ADDENDUM NUMBER 04

DATE: February 02, 2024

PROJECT: Cass District Library Edwardsburg, MI

PROJECT NUMBER: 22-1836

1 FOUNDATION PLAN  
S1.0 1/8" = 1'-0"

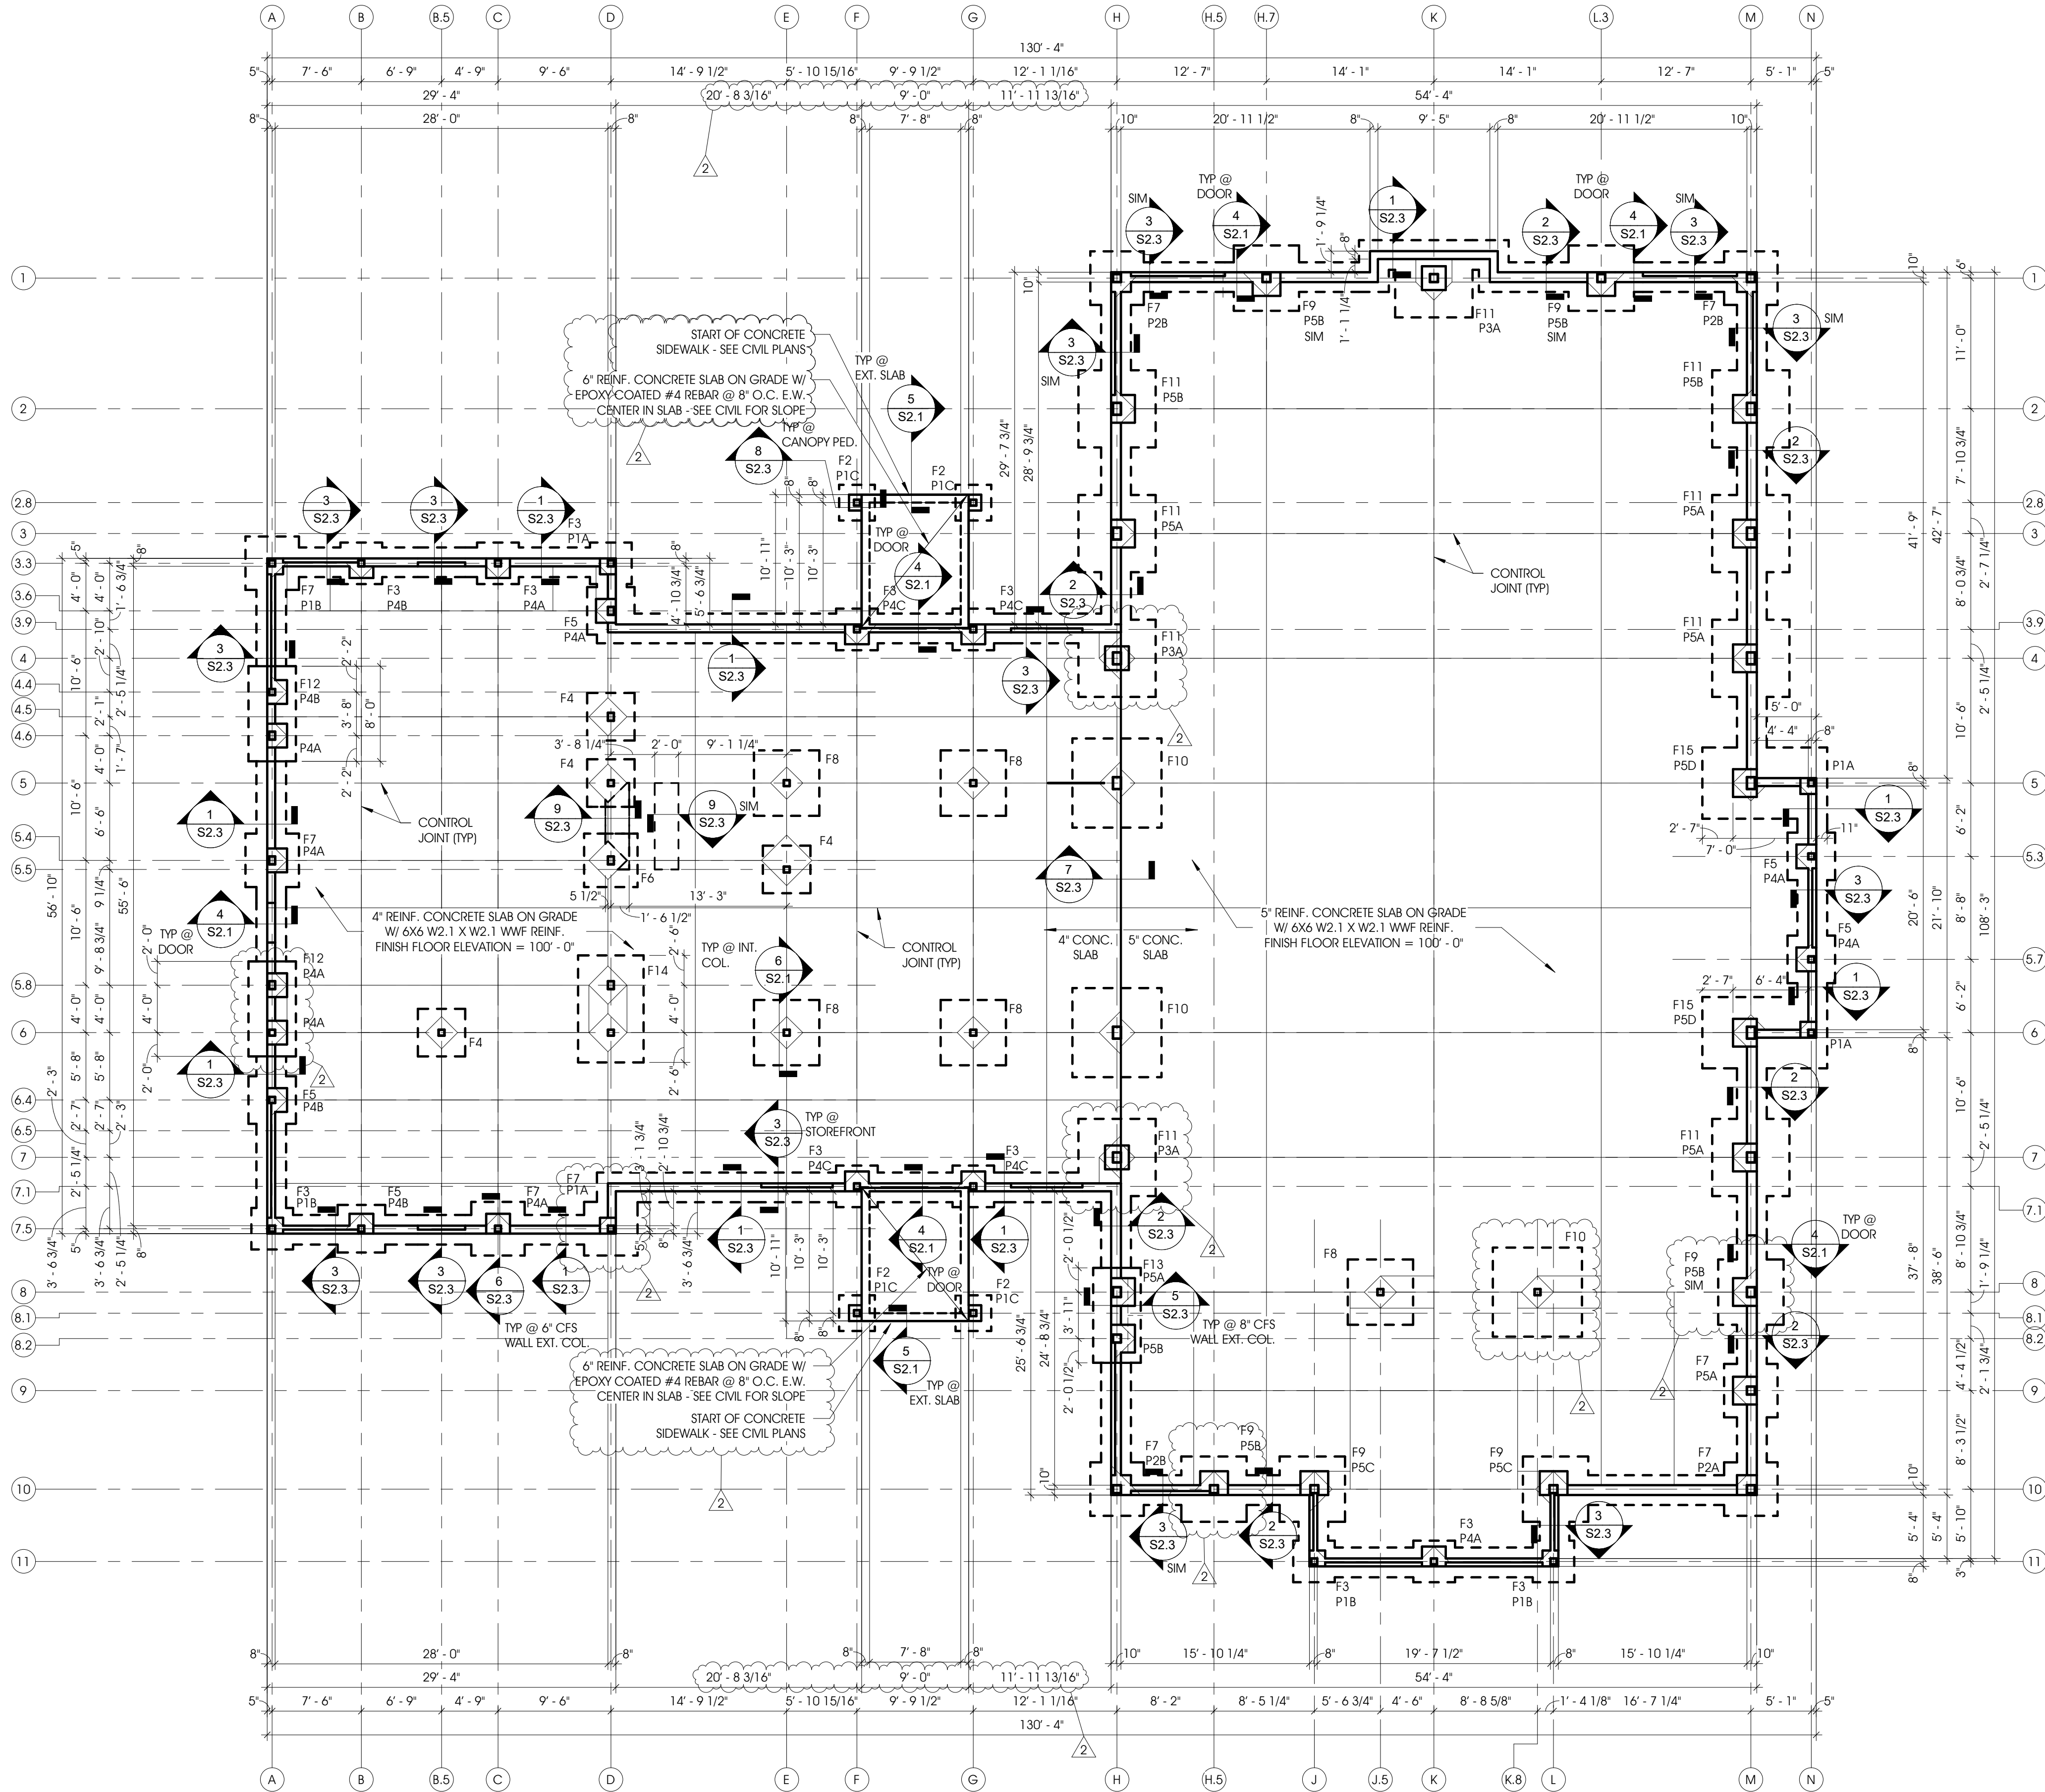
9. **REVISE** Footing Schedule, and exterior concrete slabs under entrance canopies.

4 PERGOLA FOUNDATION DETAIL  
S2.3 1" = 1'-0"

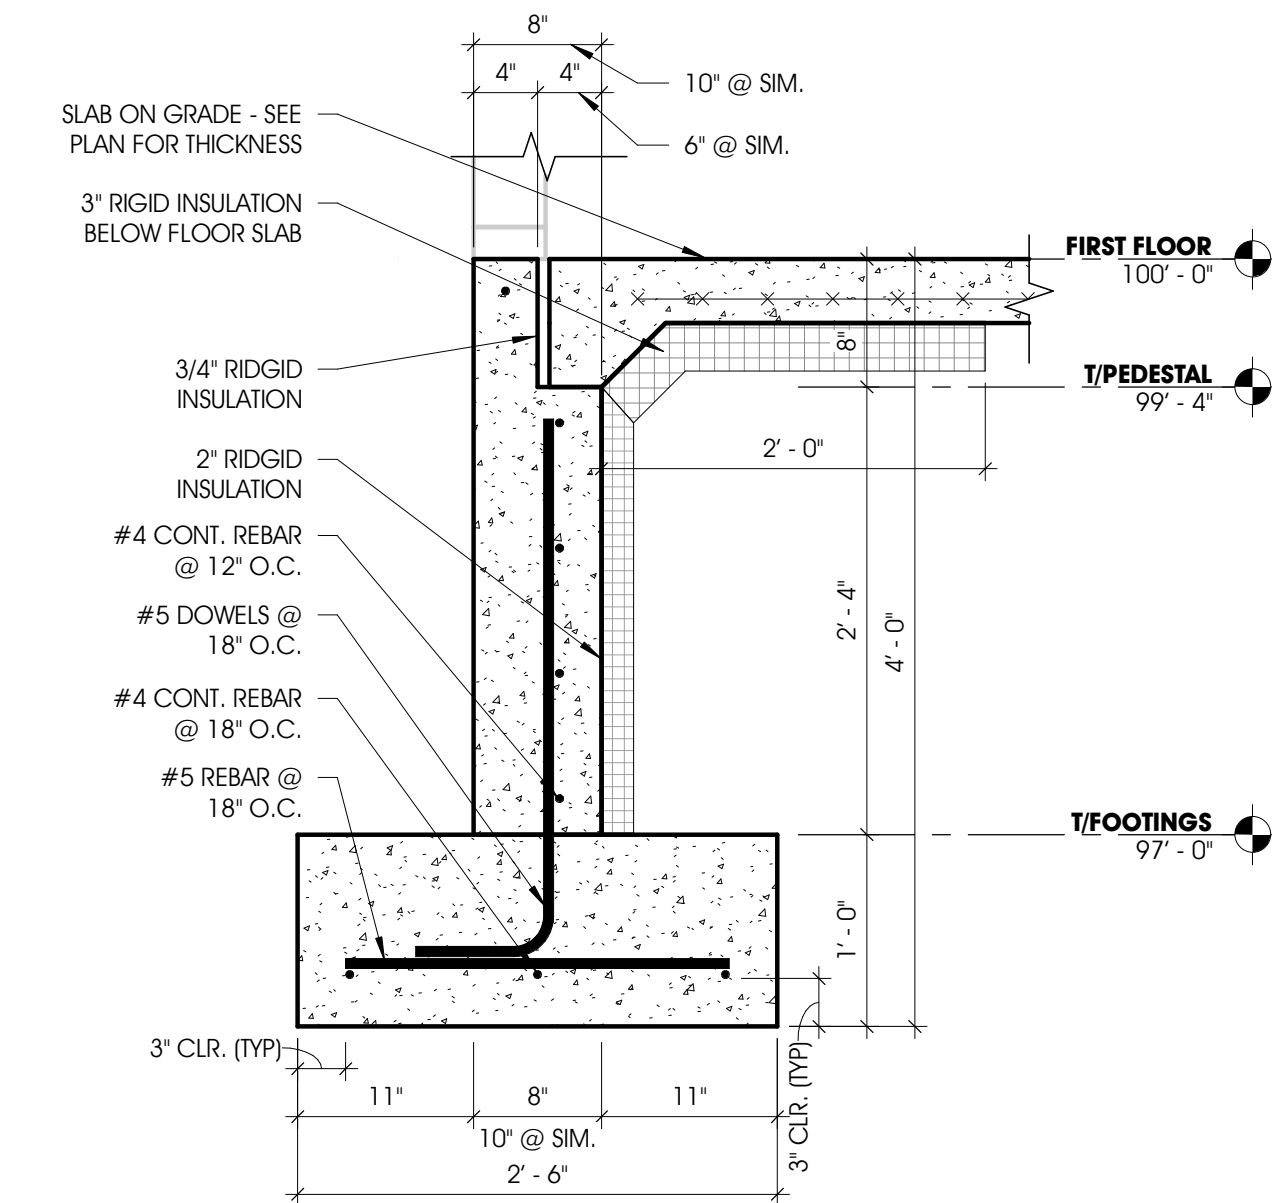
11. **REVISE** Pergola Foundation Detail 4 including clarifications on pedestal and footing elevations and trim covering Simpson post base.
